SAFETY EVALUATION BY THE OFFICE OF NUCLEAR REACTOR REGULATION
RELAXATION REQUEST FROM ORDER EA-03-009 REGARDING THE
CONTROL ELEMENT DRIVE MECHANISM EXAMINATION
FACILITY OPERATING LICENSE NO. NPF-38
ENTERGY OPERATIONS, INC.
WATERFORD STEAM ELECTRIC STATION, UNIT 3
DOCKET NO. 50-382

Figure 1

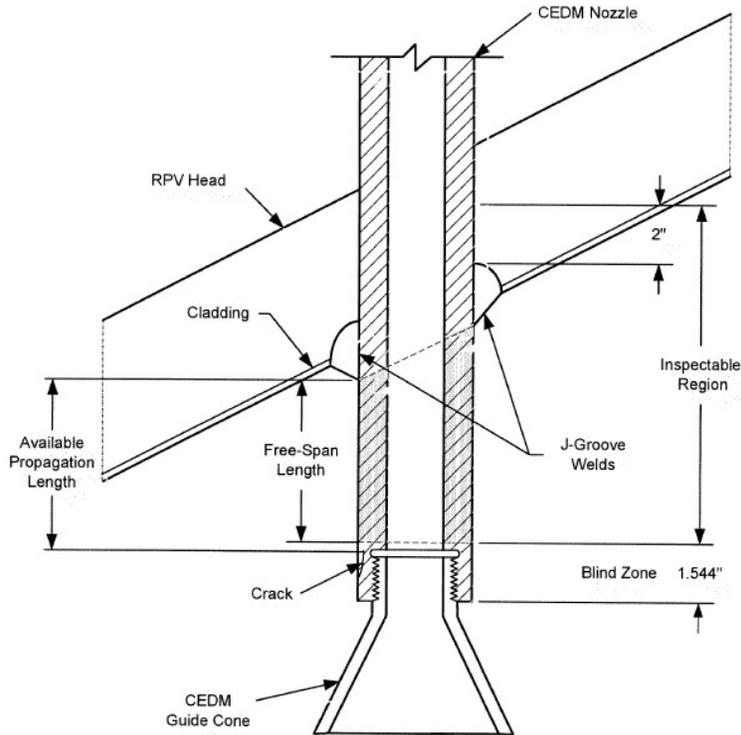
The licensee states that the inside diameter (ID) surface of each CEDM nozzle (i.e., nozzle base material) shall be ultrasonically examined from two (2) inches above the J-groove weld to 1.544 inches above the bottom of the nozzle. The licensee states that it will also perform an assessment to determine if leakage has occurred into the interference fit zone, as currently specified in Section IV.C(1)(b)(i) of the Order. Figure 1 is from the licensee's September 15, 2003 submittal and shows the inspection areas of a CEDM nozzle as defined by the licensee.

The licensee states that guide cones are attached to the bottom of the Waterford 3 CEDM nozzles via threaded connections and screw into the end of the CEDM nozzles with a welded set screw and two tack welds at the cone-nozzle interface to secure the guide cone to the nozzle. In addition, there is a chamfer at the top of the threaded region that is 0.094 inch in length and the threaded region is 1.25 inches.

The licensee states that meaningful UT data cannot be collected in the threaded area or the chamfer region, since the chamfer region geometry causes sporadic signals. The licensee further states that, once the guide cone is reached, sound cannot pass into the CEDM nozzle base material because of the gap that exists between the guide cone and the nozzle at the threaded connection. This leaves a length of 1.344 inches ($1.25 + 0.094$) at the bottom of the CEDM nozzle that cannot be inspected by UT examination due to nozzle configuration.

The licensee states that, in addition to the limitations of inspecting the chamfer and threaded area of the bottom of the CEDM nozzles, there are limitations regarding the inspection probe's ability to collect data 0.2 inches above the chamfer area. The licensee states that the inspection probe that is to be used for the Waterford 3 CEDM nozzles consists of seven individual transducers. The transducers consist of one pair used for circumferential scanning using time-of-flight diffraction (TOFD), one pair for axial scanning using TOFD, two standard zero-degree scan transducers and one eddy current transducer. These transducers are slightly recessed into the probe holder that must be filled with water to provide coupling between the transducers and the nozzle wall. The licensee indicated that based on prior UT examination experience and a review of UT data from previous inspections, the circumferential-scanning TOFD transducer pair only collects data down to a point 0.200 inch above the chamfer. This makes the total distance at the bottom of the nozzle that cannot be UT inspected equal to 1.544 inches (1.25 in threads + 0.094 inch chamfer + 0.2 inch). The licensee refers to this area as the "blind zone" and states that UT data can not be collected from this area.

The staff concludes that the licensee's proposed alternative examination of the CEDM RPV head penetration nozzles using UT from 2 inches above the J-groove weld to 1.544 inches above the bottom of the CEDM nozzles, provides reasonable assurance of the structural integrity of the RPV head, VHP nozzles, and welds. Further inspection of the CEDM nozzles in accordance with Section IV.C.(1)(b)(i) of Order EA-03-009 would result in hardship or unusual difficulty without a compensating increase in the level of quality and safety. Therefore, good cause has been shown for relaxation of the Order, and pursuant to Section IV, Paragraph F, of Order EA-03-009, and 10 CFR 50.55a(a)(3), the staff authorizes, for one operating cycle commencing with the startup from the fall 2003 refueling outage, the proposed alternative inspection for all CEDM head penetration nozzles at Waterford 3, subject to the following condition:
